**IN THE MATTER OF** Proposed Plan Change 14 Housing and  
Business Choice pursuant to Part 5, subpart  
5A and Part 6 of Schedule 1 of the Resource  
Management Act 1991

**MINUTE 57: RESPONSE TO COUNCIL FURTHER FINAL CLARIFICATIONS**

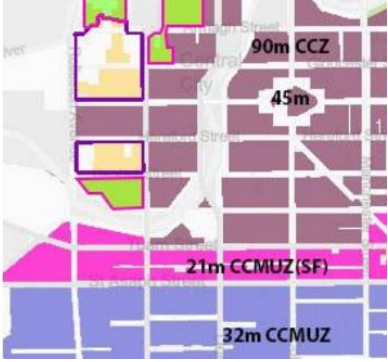
3.	Central City Building Heights Map	Chapters 15.12, 15.13, Central City Mixed Use (South Frame) Zone and Health Precinct area	Minute 51	Part 3	<p>Council sought clarification from the Panel regarding the Central City building heights map in Minute 51 – item 21.</p> <p>Within the Panel's Recommendations it is unclear what the recommendation is for the Central City Mixed Use (South Frame) (CCMU(SF)) zoned sites in the area shown as the 'Health Precinct' on the <i>Central City Core, Frame, Large Format Retail, Innovation, Retail and South Frame Pedestrian Precincts Planning Map</i><sup>5</sup> in the operative Plan as shown in the snip below.</p> 	<p>The application of heights within the Health Precinct was not addressed by the Panel, nor was it supported by a s32 evaluation by the Council. It appears to have been a complete omission by the Council and the Panel, save a reference on a planning map.</p> <p>The Panel's Recommendations in Part 3 of our Report was structured on the basis of the Zone that applied in the context of the NPS-UD Policy 3(a), (c)(ii) and (d) required enablements, i.e. the heights for CCZ is a Policy 3(a) response whereas the heights in the CCMUZ(SF) is a Policy 3(c)(ii) response (addressed in Part 3, section 4 of the Recommendation Report see [236] and at [253]-[256]). We note that in [260] the Panel addressed residential intensification precincts, but did not refer to the Health Precinct in [261].</p> <p>The Council did not address the effect of the Health Precinct on the requirements of Policy 3(c)(ii) in evidence before the Panel.</p>

#	Key Theme	Chapter/ Provision	Previous Minute (s)	Panel Recom menda tion Part #	Matter for Panel clarification	IHP Response / Comment
					<p>The area outlined in blue is the 'Health Precinct' in the block of St Asaph Street, Hagley Avenue, Cambridge Terrace and Montreal Street.</p> <p>The blocks highlighted in green and orange are the areas subject to this matter for the Panel's clarification.</p> <p>In the operative Plan, the area in green has a height limit of 28m and the area in orange has a 30m height limit. Therefore, a building height limit of 21m for these areas, if the broad CCMU(SF) zone height limit recommendation is applied, <b>would be less enabling than the operative Plan.</b></p> <p>The remaining unhighlighted block within the blue area has a height limit of 17m in the operative Plan, and the Council does not have concerns regarding the recommended CCMU(SF) height limit of 21m.</p> <p>These areas were shown in the notified Central City Building Height Map with height limits as noted below.</p> <p>Purple being the 90m height overlay, yellow being the 32m overlay, and pink being the 21m overlay.</p>	<p>The Panel did not consider the appropriateness of a 90m height proposed in the green and orange area within the Health Precinct as part of its evaluation, nor does it appear that the Council did in its preparation of PC 14 as there is no accompanying s32 evaluation or appended technical reports to support the change as notified.</p> <p>The Panel does not recall having raised the matter of the Health Precinct at the hearing nor it being raised by any other person.</p> <p>The Panel did not intend or envisage that there would be any 'spot' height of 90m/or no height limit in this location. Had the issue been brought to our attention we would have made further comment or sought a response from Council witnesses as to how and why this was an appropriate method to give effect to Policy 3, or how it otherwise met the requirements of s32.</p> <p>The issue of whether the height should be different in the CCMUZ(SF) within the Health Precinct overlay as a consequence of PC 14 was not brought to the attention to the Panel by Council s42A Report authors.</p>

#	Key Theme	Chapter/ Provision	Previous Minute (s)	Panel Recom menda tion Part #	Matter for Panel clarification	IHP Response / Comment
					<p>include the height for these specific areas on the Central City Building Heights Planning Map.</p> <p><b>Can the Panel please clarify its recommendations on this matter?</b></p> <p>Further to the above, it is noted that at Part 3, paragraph [290] the Panel recommended consequential changes to Rules 15.12.1.3 RD2 and 15.12.1.3 RD5, for consistency reasons, to provide that buildings up to 17m in height are permitted. However, these rule references relate to the Central City Mixed Use Zone where buildings up to 17m are already provided for as permitted activities.</p> <p>Did the Panel mean for these rules to be those at 15.13.1.3 RD2 and 15.13.1.3 RD5 for the Central City Mixed Use Zone (South Frame)?</p> <p><b>Could the Panel please clarify what was meant by these consequential changes?</b></p>	<p>The Property Economics Report referenced in the footnote appears in Appendix 3 to Part 4 of the Section 32. That report is silent on the costs and benefits or appropriateness of additional height in the Health Precinct and firmly rejects additional height beyond that proposed more generally for in the CCMUZ(SF) zone.</p> <p>In light of the above quote from the s32 Report, the Panel wonders if the 90m height limit shown on the notified PC 14 'Maximum Building Height Planning Map' for this location was an error or had been mistaken for a CCZ zoned area in the production of the PC 14 planning maps and in the s32 evaluation?</p> <p>Applying the same enabled heights as in the CCZ in response to the NPS-UD Policy 3(c)(ii) at this location appears inconsistent with the recommendations of Property Economics, the centres hierarchy and the approach that the Council took to submitter requests to increase heights in other commercial centres due to the impact on the centres hierarchy and the importance accorded to the CCZ. It is also contrary to the Panel's recommendations in Part 3 of the Recommendation Report where the Panel rejected submissions where those</p>

#	Key Theme	Chapter/ Provision	Previous Minute (s)	Panel Recom menda tion Part #	Matter for Panel clarification	IHP Response / Comment
						<p>submissions were found to potentially disrupt the centres hierarchy.</p> <p>The Panel is not now able to consider whether an exception is appropriate in this location in accordance with RMA s32/32AA. There is no evidential basis to support an evaluation of the change in height to match the same heights enabled in the CCZ in accordance with NPS UD Policy 3(a) as suggested by the Council in its requested clarification.</p> <p>The Panel agrees that to the extent that PC 14 recommendations would be less enabling than the operative height limit, the operative height limit (as provided by the operative Health Precinct) should prevail as is the case in the Panel's recommendations for other zones where an operative provision is more enabling. There was no intention of the Panel to remove existing height entitlements in the operative plan and these must be preserved in the same way we recommended for the relevant residential zones in the Four Avenues at [260].</p> <p>To answer the Council's request for clarification, noting that the Panel did not have any evidence to support the notified height limit, the Panel can only conclude that there is no evidential basis to</p>

#	Key Theme	Chapter/ Provision	Previous Minute (s)	Panel Recom menda tion Part #	Matter for Panel clarification	IHP Response / Comment
						<p>support an exception to the CCMUZ(SF) beyond the Panel's recommendations for the CCMUZ(SF) zone in Part 3 of the Recommendation Report, which includes retaining any status quo operative plan entitlements.</p> <p>In these circumstances, had the matter been raised in the hearing, the Panel would have recommended that the update to the Central City Heights Planning Maps should therefore reflect the PC 14 enabled heights for that zone as is the case for or recommendations with the relevant residential zones, except where the operative plan enabled greater heights. See the Panel's response to the clarification requested in Minute 51, item 21. This clarification and Panel response did not refer to the Health Precinct.</p> <p>Yes these should have referred to 15.13 version of the rules.</p>
